ADDENDUM SHEET

DEVELOPMENT MANAGEMENT COMMITTEE

2nd September 2021

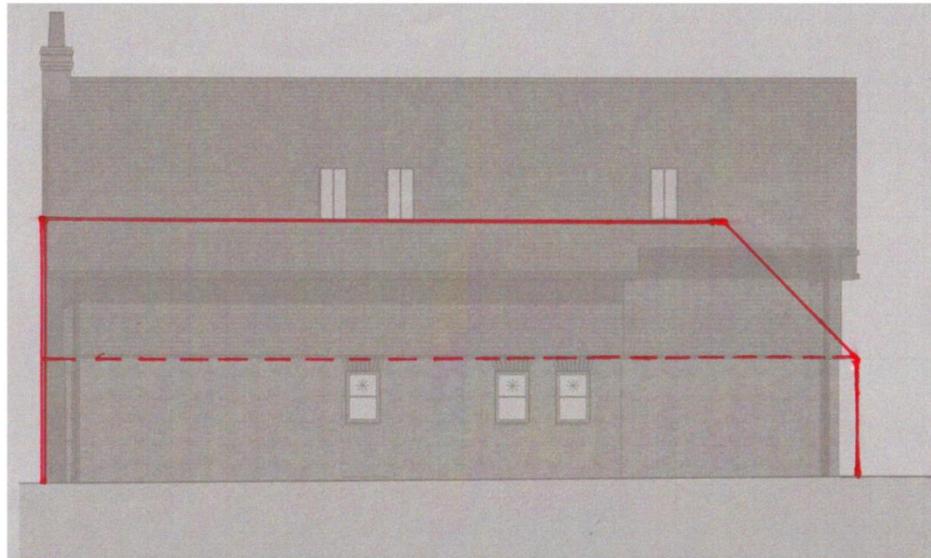
The inclusion of the superimposed image and dimensions of the existing building on the front view “street scene” of the proposed new building is helpful but does not address the view from our facing window. The marked up drawing below, using the dimensions from Mr Higenbottam’s input, shows in red the outline of the current

building in relation to the proposed replacement of the north-west facing wall which is what we see from our house.

It shows more starkly that the impact will be substantial when viewed from Kingshill, not just because of the increased height, which we recognise is consistent with both our house and those surrounding, but also the length of the roof ridge, which appears now to be approaching 16m, and extends to the full length of the building rather than tapering down to gutter height, with a hipped end. All the other houses in this cul-de-sac, whilst of similar height, have hipped roof designs which mitigate the effect on surrounding properties of the height of adjacent buildings, and none has a continuous ridge length of anything approaching 16m.

STREET ELEVATION

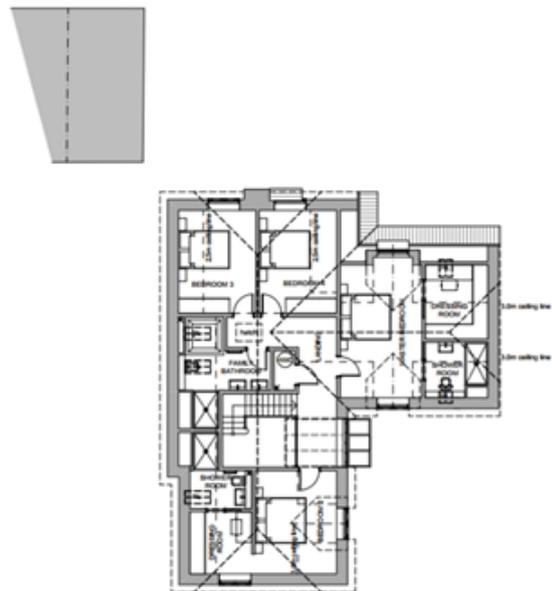
In response to these comments, the planning agent amended the plans to include the provision of half-hipped roofs to the three ends of the buildings instead of the gables originally shown on the plans. The original and amended plans are set out as follows:

Officers consider the amendments shown on the plans to be acceptable.

**2270/02G;
2270/03G;
2270/04B;
2270/05B.**

Slide 8

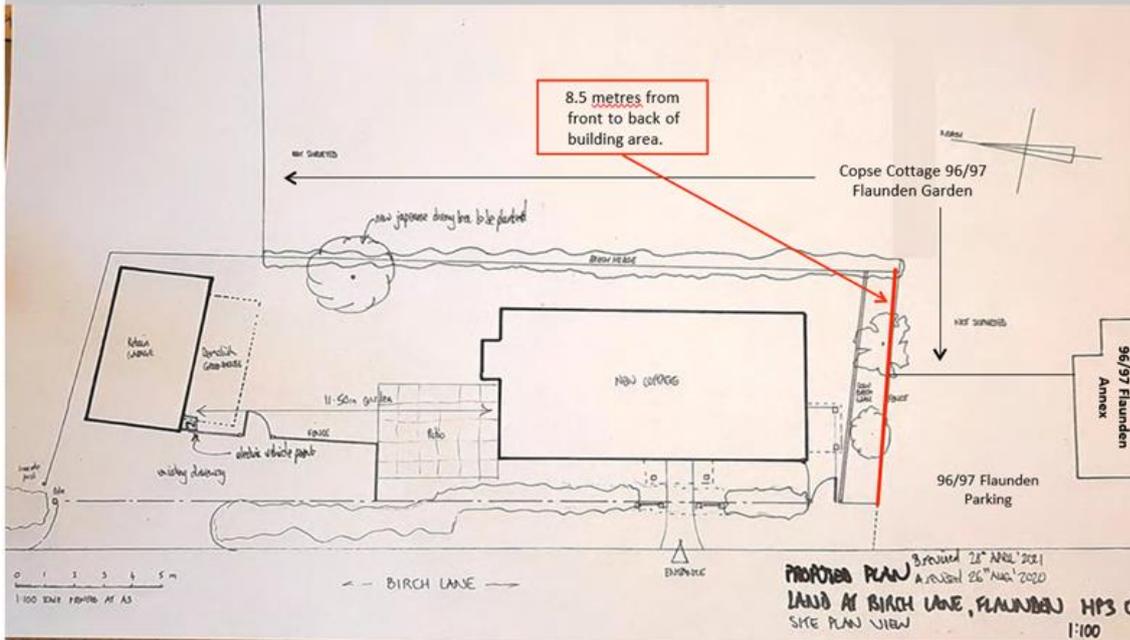
On viewing the plans it is apparent how restricted the area is, with the actual depth of plot available to build on being restricted to 8.5m at the southern boundary, widening to 10.5m at the northern end.

Slide 9

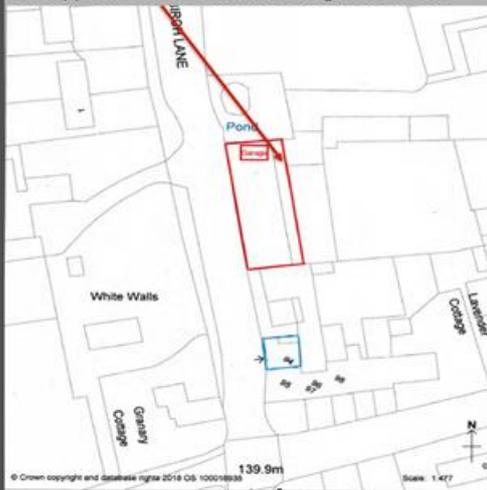
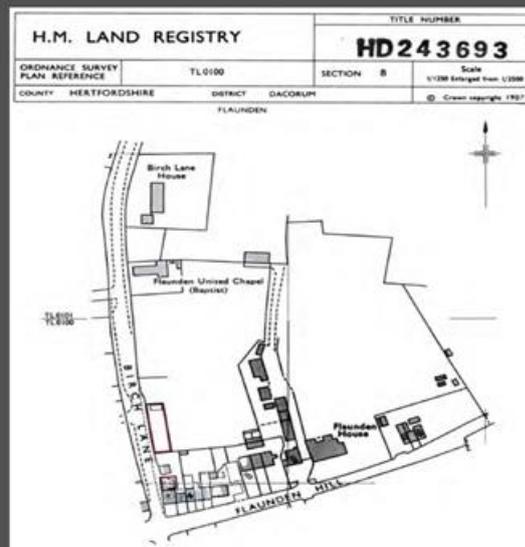
Photo on left is title plan submitted for 94 Flaunden. Arrow indicates the strip of land which is part of 96/97 Copse Cottage's land.

As this plan is shown in the application this give the appearance that the site is larger than it is.

Below - Land Registry document for 94 Flaunden which correctly show boundaries.
